UN Regulation No. 129 (Enhanced Child Restraint Systems)

Proposal for draft Supplement 8 to the 01 series of amendments to Regulation No. 129 (Enhanced Child Restraint Systems)

Submitted by the expert from Spain*

Figure 3
Minimum distance for lateral impact

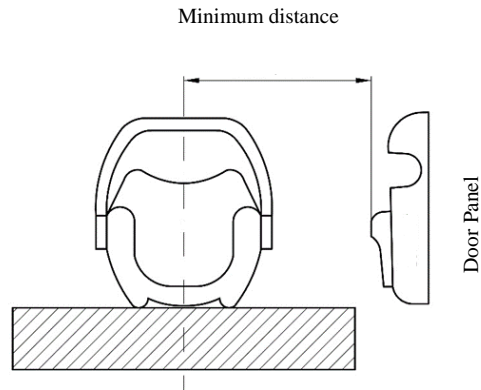
For each test, the initial position of the side impact door panel relative to the bench shall be adjusted according to the minimum distance between the vehicle's door panel and the centre of the seating position as shown in figure 3.
